# 435 DEXTER

August 6, 2014  
Design Review  
Recommendation #2  
DPD Project# 3016347

North Elevation: Summary of Responses to Recommendation

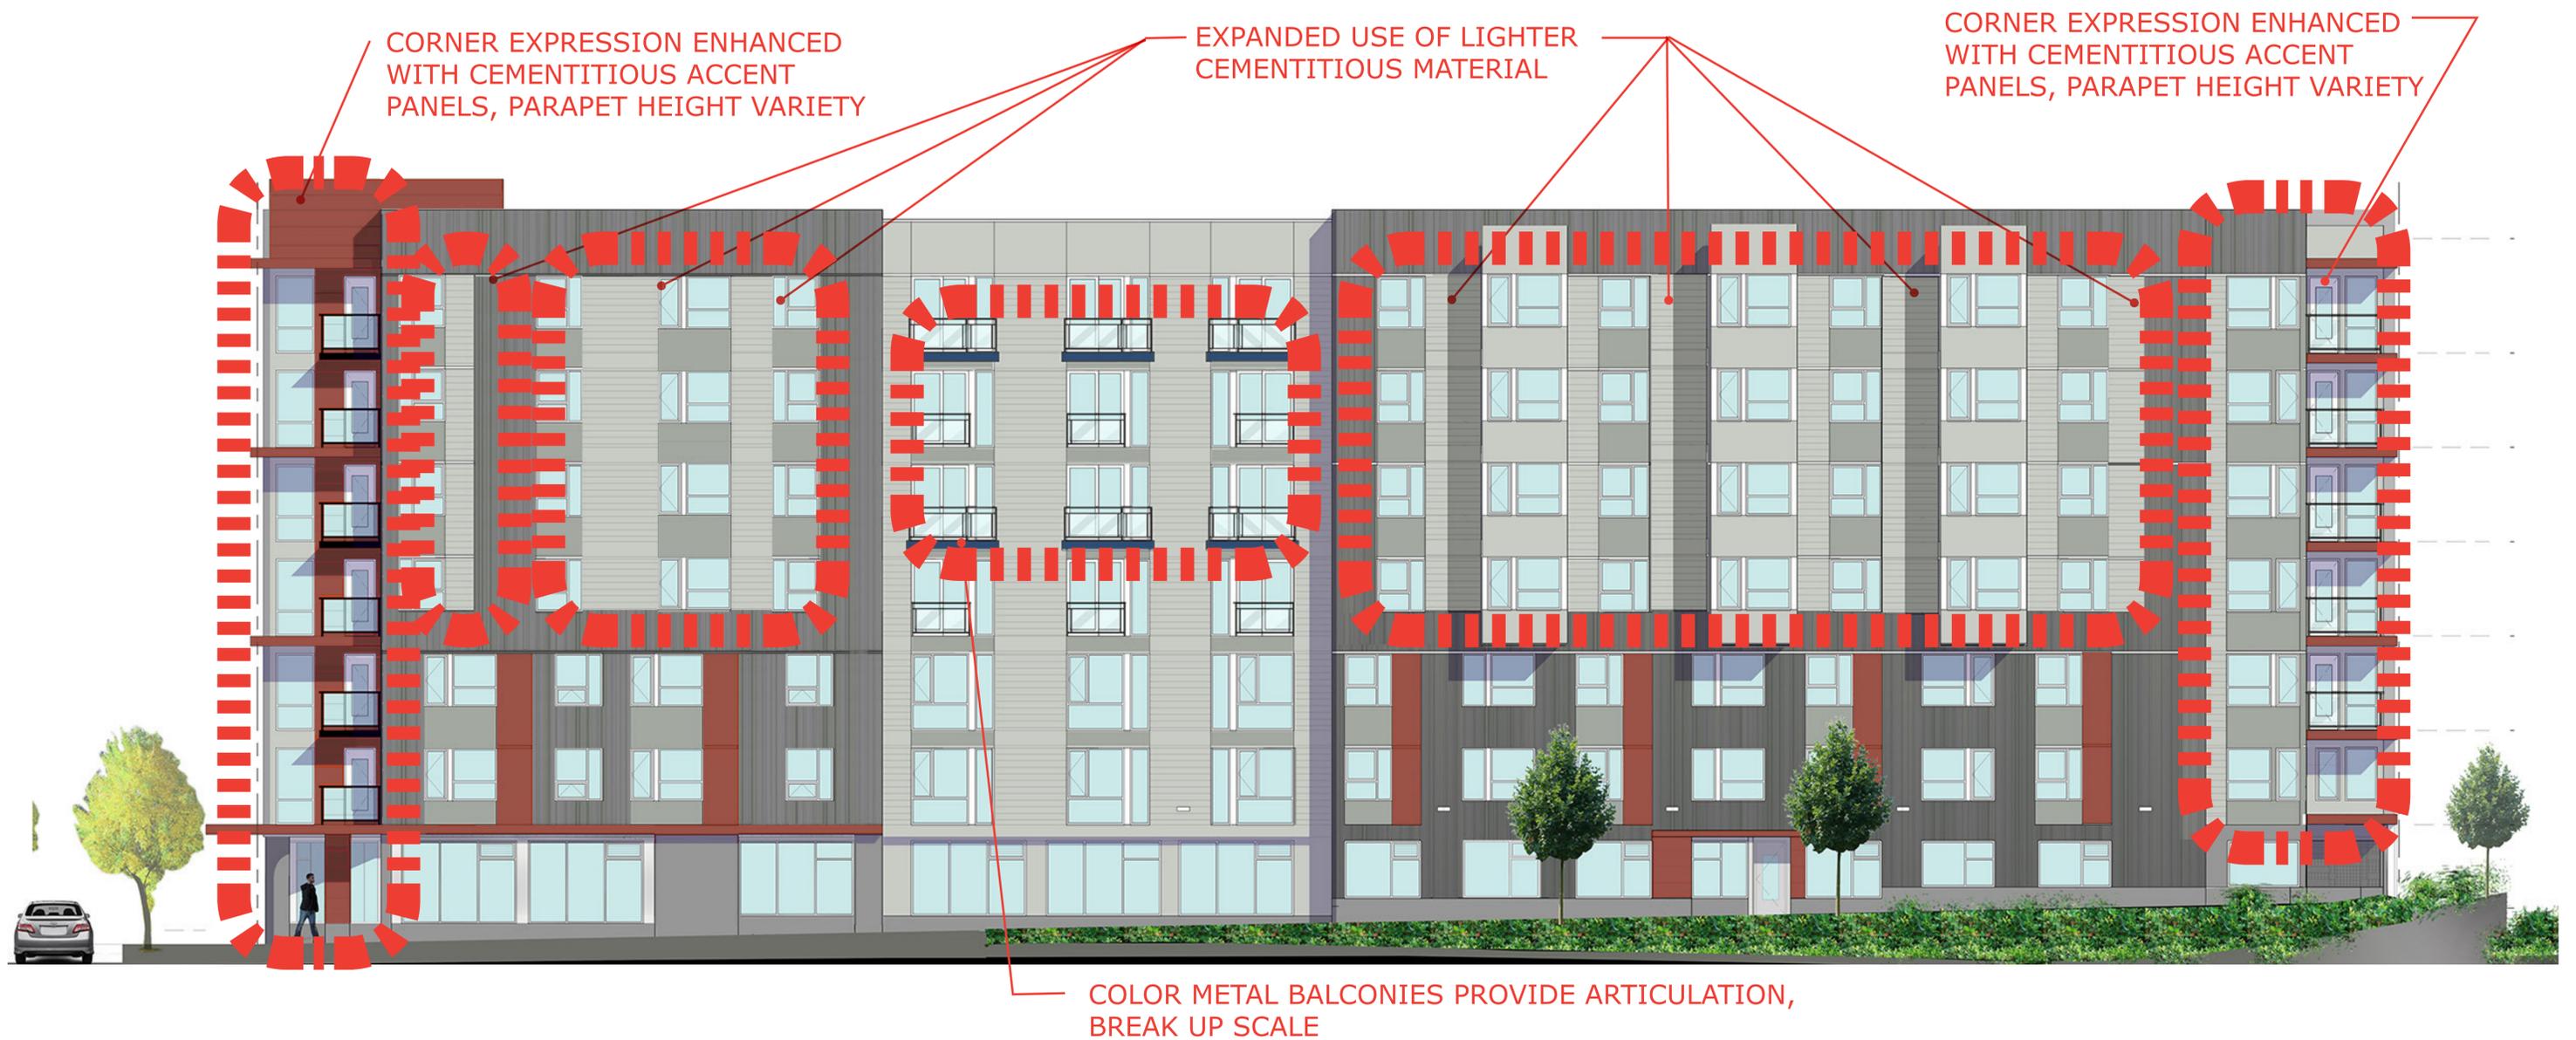
## 2. Scale and Architectural Concept: Initial Recommendation

- North and west facades need reduction in scale
- Concept of contrast between dark shell and light core not expressed at North and West
- Color, materials, and proportions of Dexter facade should be applied to North and West

### Applicant Response

- Reduced dark metal and increased light colored panel to reduce scale and increase contrast between heavy shell and lighter core expression
- Facade treatment at lower floors at Dexter extended to North and West
- West facade with revised corners to reflect visual prominence and proportions similar to Dexter facade

West Elevation: Summary of Responses to Recommendation

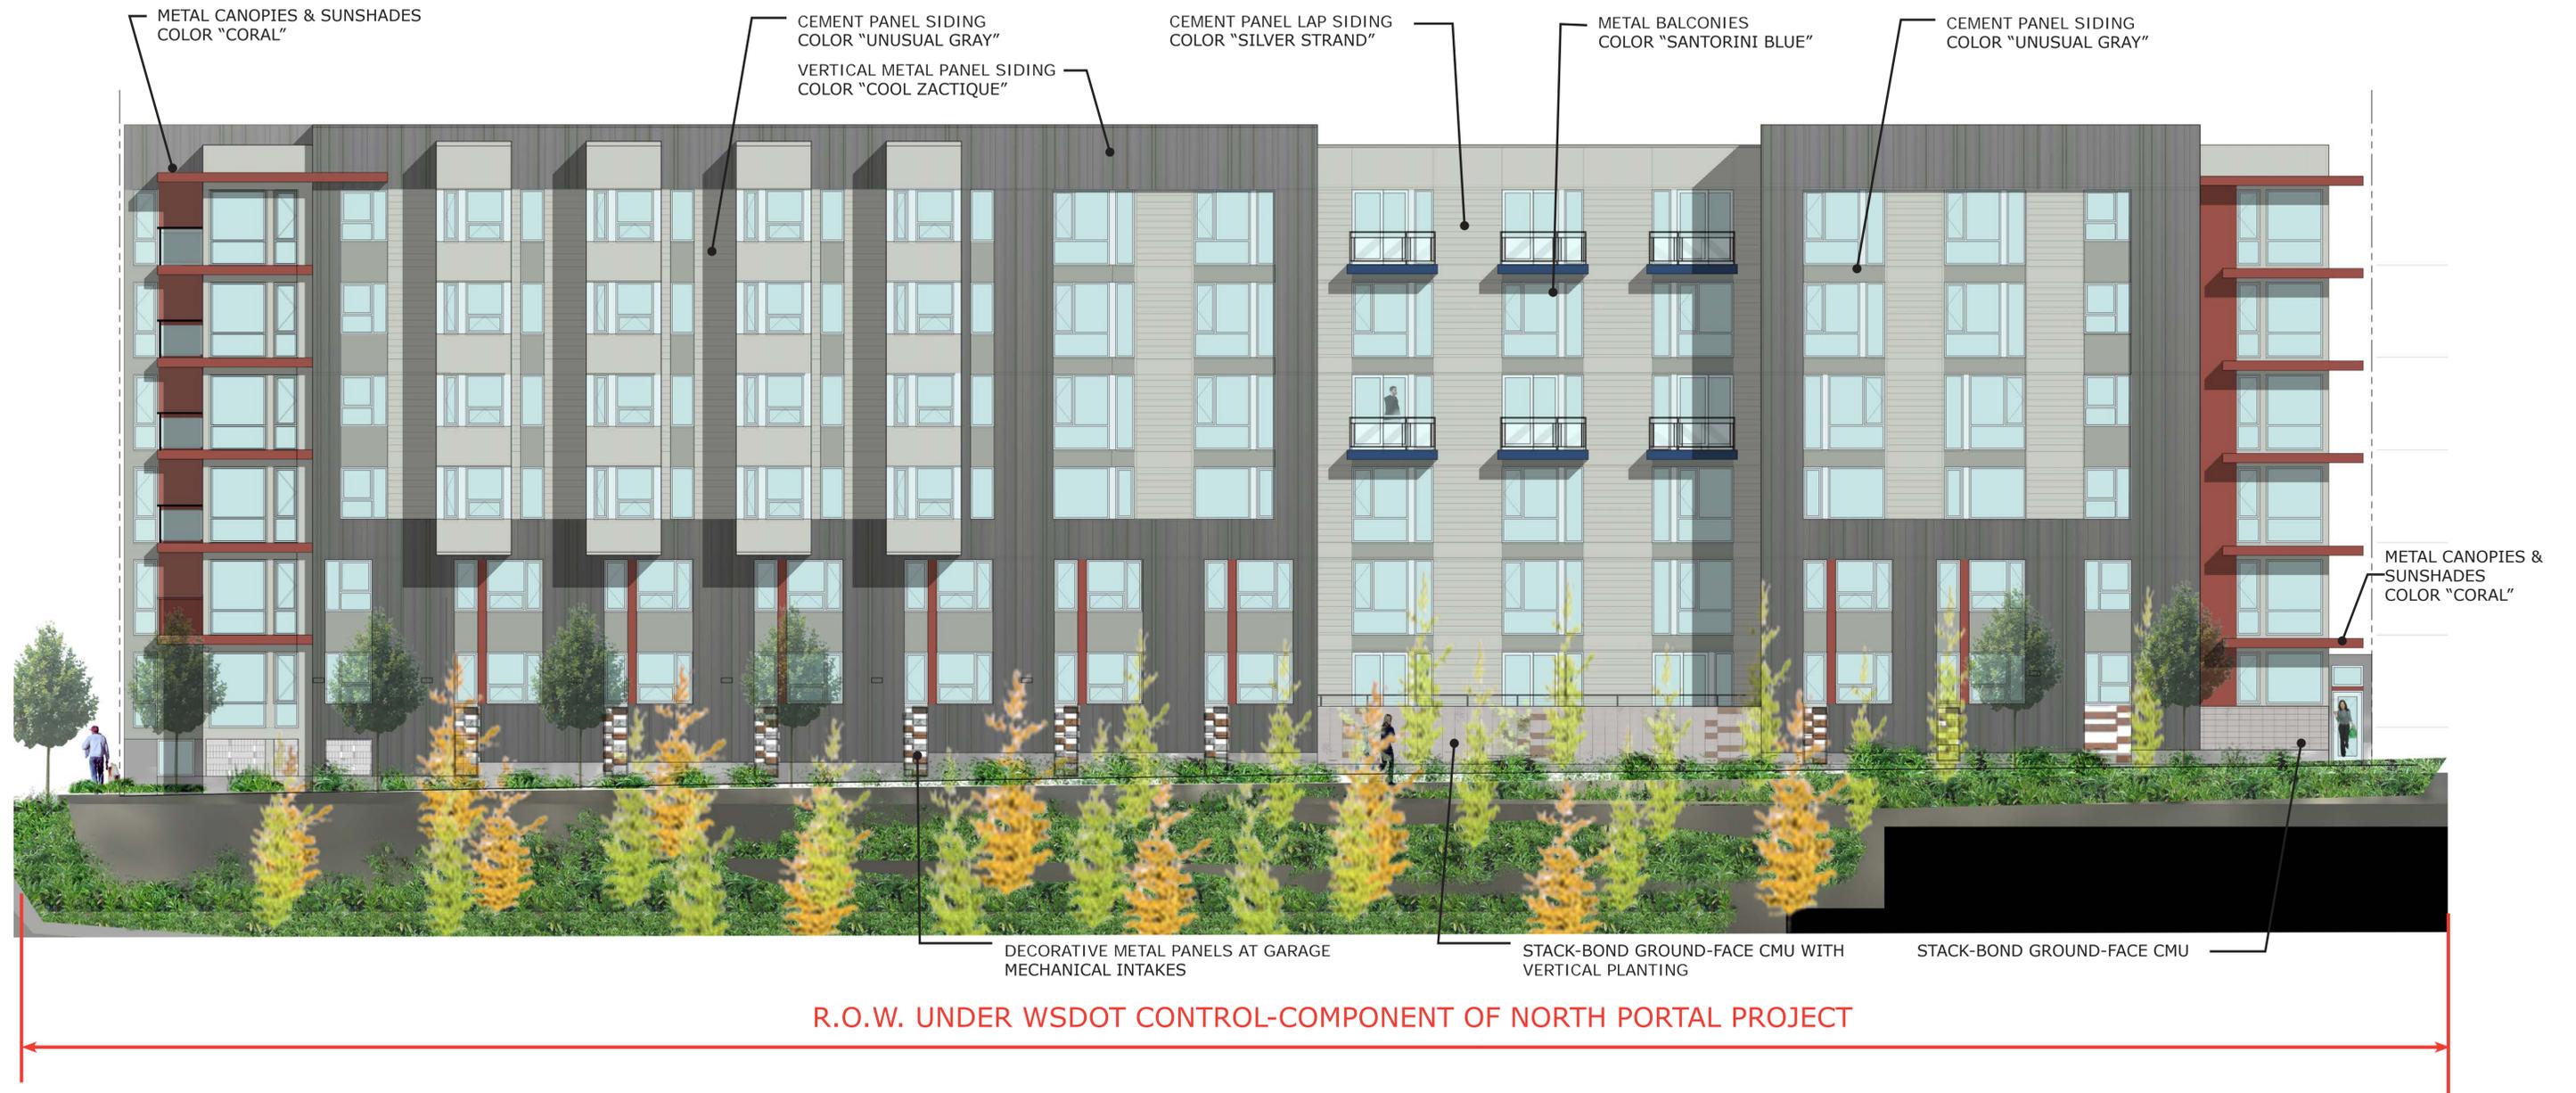
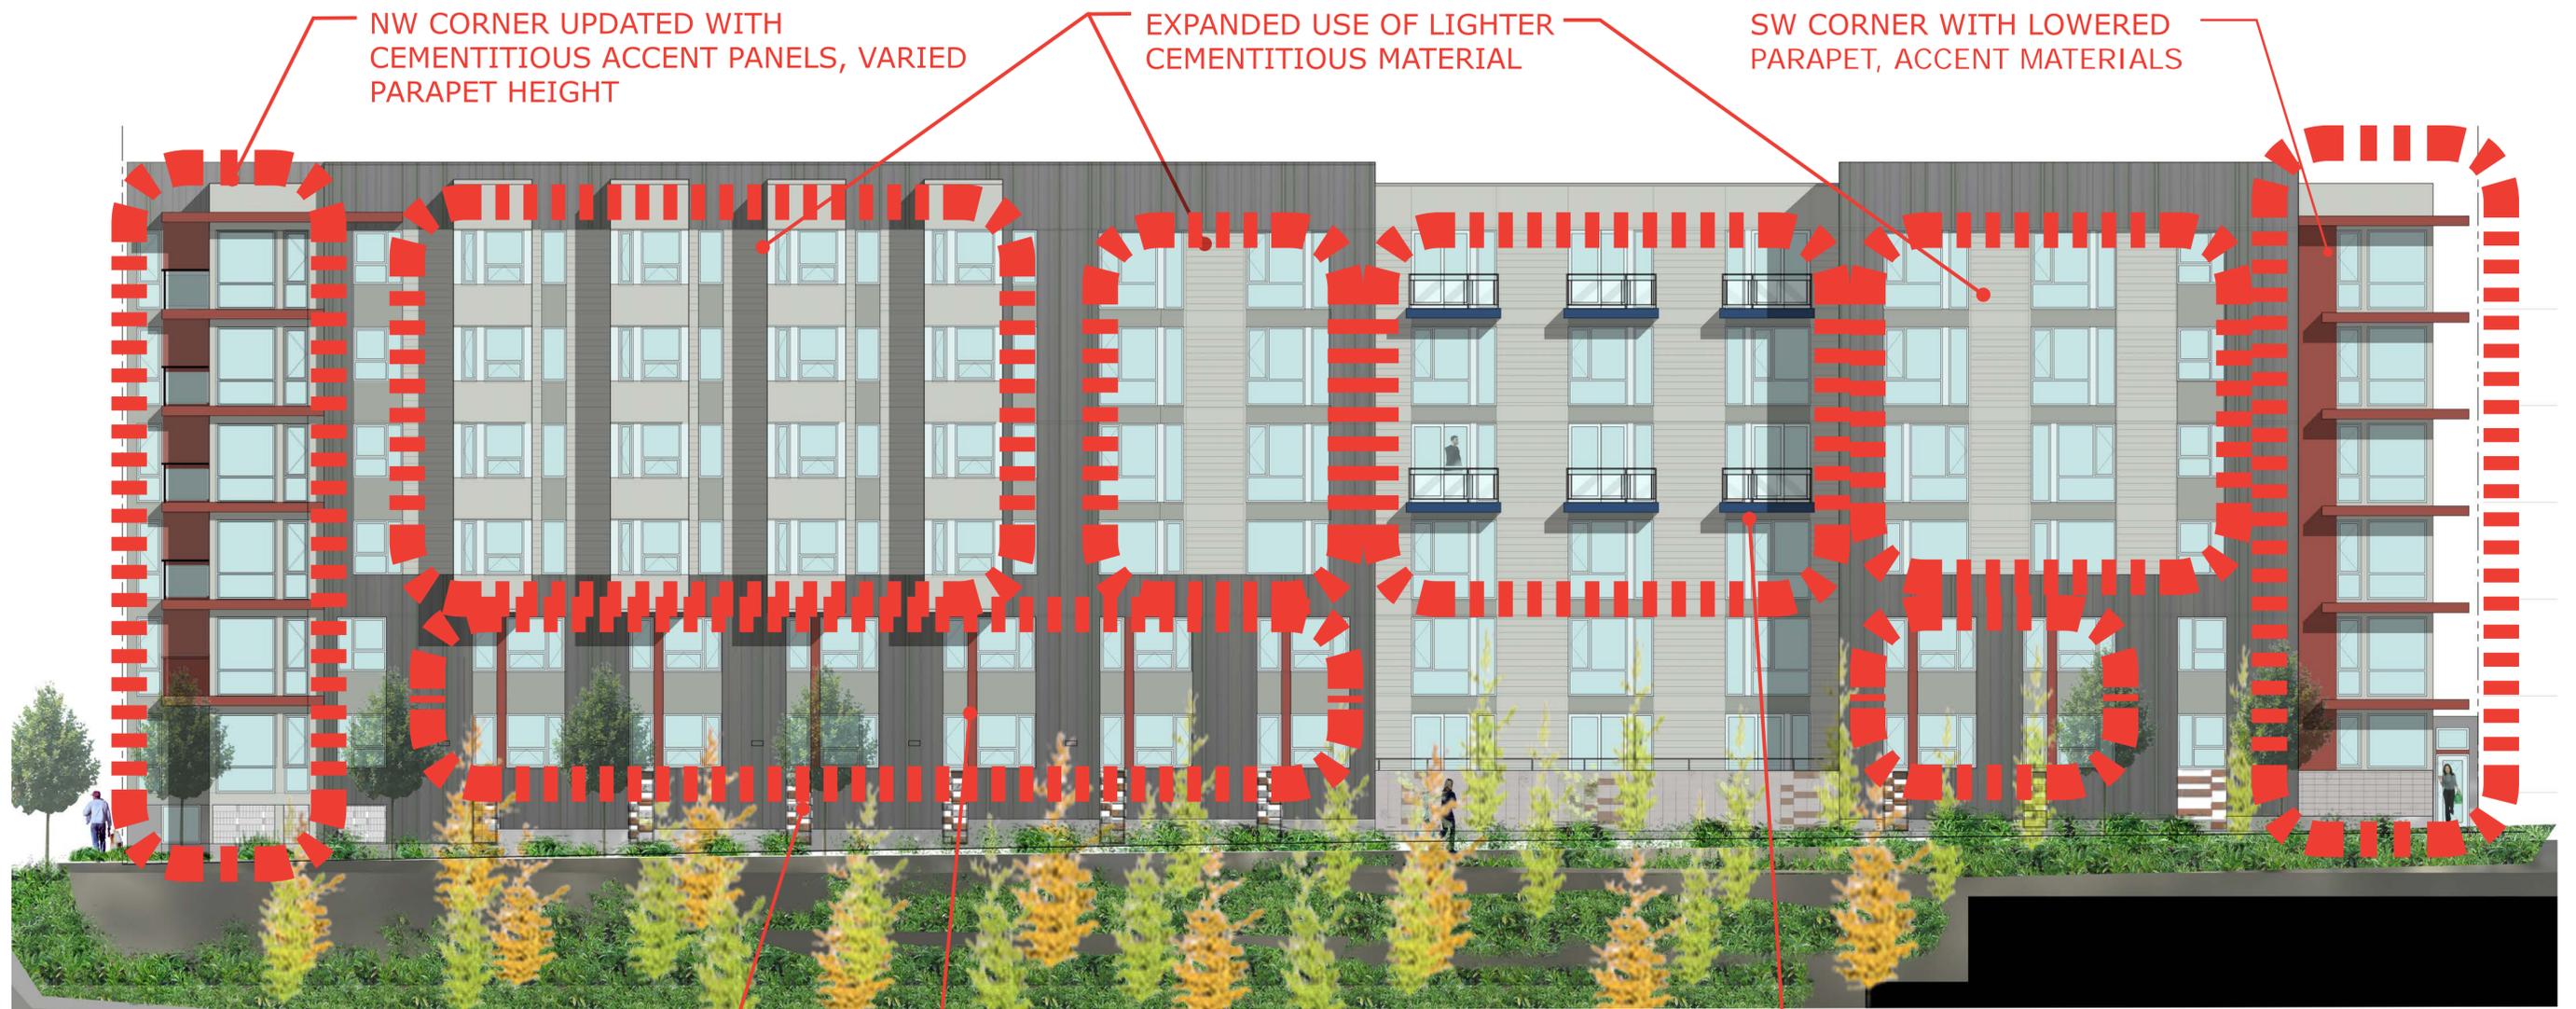
## 2. Scale and Architectural Concept: Initial Recommendation

- North and west facades need reduction in scale
- Concept of contrast between dark shell and light core not expressed at North and West
- Color, materials, and proportions of Dexter facade should be applied to North and West

## 2. Scale and Architectural Concept: Applicant Response

- Increased contrast between heavy shell and lighter core expression
- Facade treatment at lower floors at Dexter extended to North and West
- Revised corners to reflect visual prominence and proportions similar to Dexter facade

DECORATIVE METAL SCREENS  
CONSISTENT WITH METAL SCREENS  
ALONG DEXTER AVE

WINDOW EXPRESSIONS WITH CEMENTITIOUS  
ACCENT COLORS RELATE TO DEXTER AVE  
FACADE

COLOR METAL BALCONIES PROVIDE  
ARTICULATION, BREAK UP SCALE

Street-Level Elevation along Highway 99

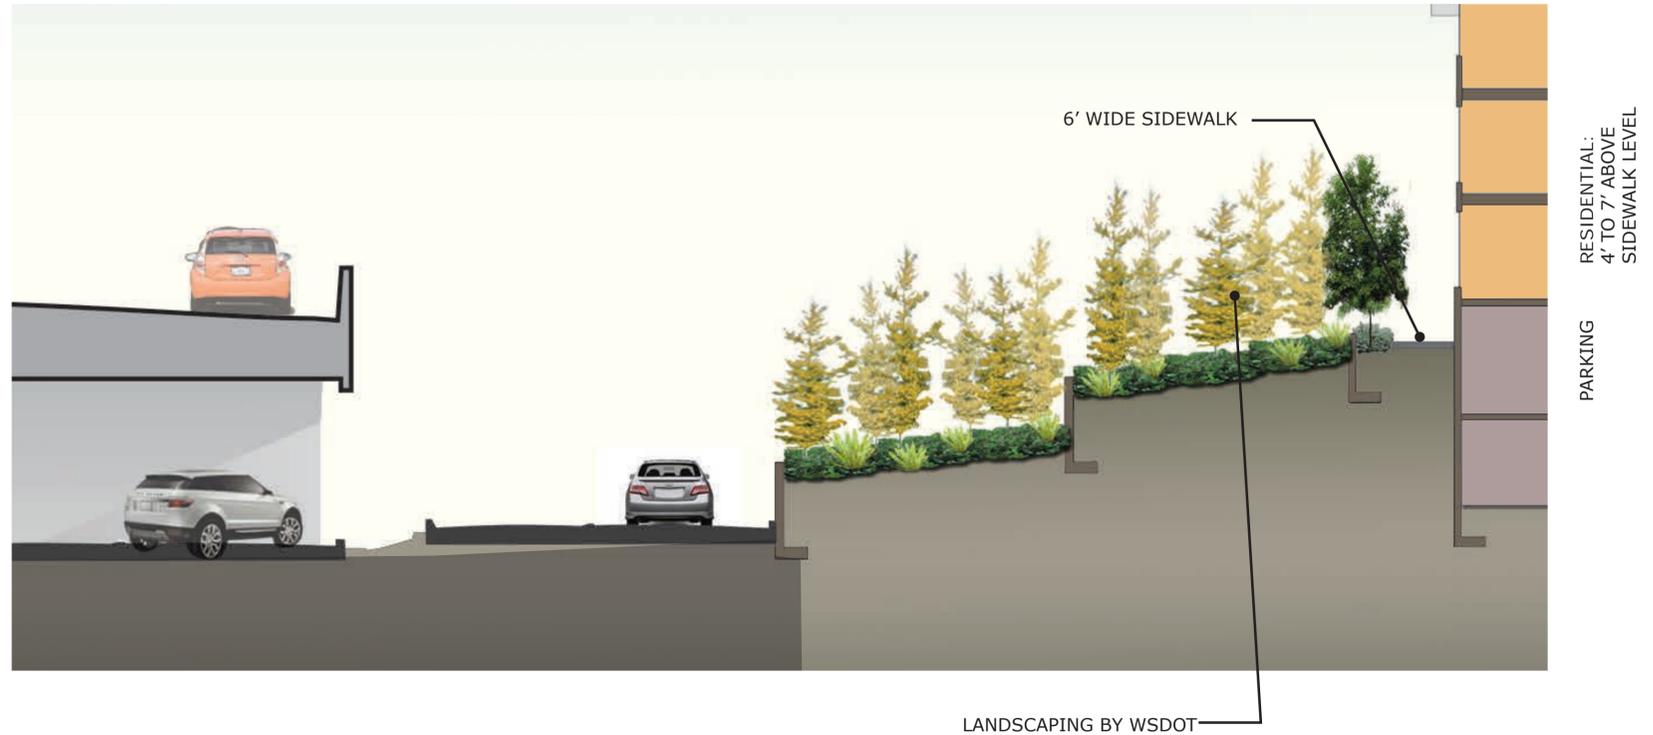
## 7. West Facade Design at Grade: Initial Recommendation

- Design treatment should respond to potential for west facade to attract graffiti.

### **Applicant Response**

- Metal siding brought down to cover blank concrete walls
- Residential units provide eyes on the street
- Wall mounted light fixtures promote pedestrian safety and discourage graffiti
- Developer is longterm owner and will aggressively remove graffiti on a daily basis

Zoning review from DPD determined that proposal does not meet the screening standards without more extensive use of landscaping and/or decorative panels.

- Material changes, vertical plantings, and decorative metal screens as shown are appropriate for specific pedestrian environment and will be screened from Highway 99 by ROW plantings and railings.
- More extensive vertical plantings and decorative screens not appropriate given anticipated pedestrian usage and limited visibility from Highway 99.
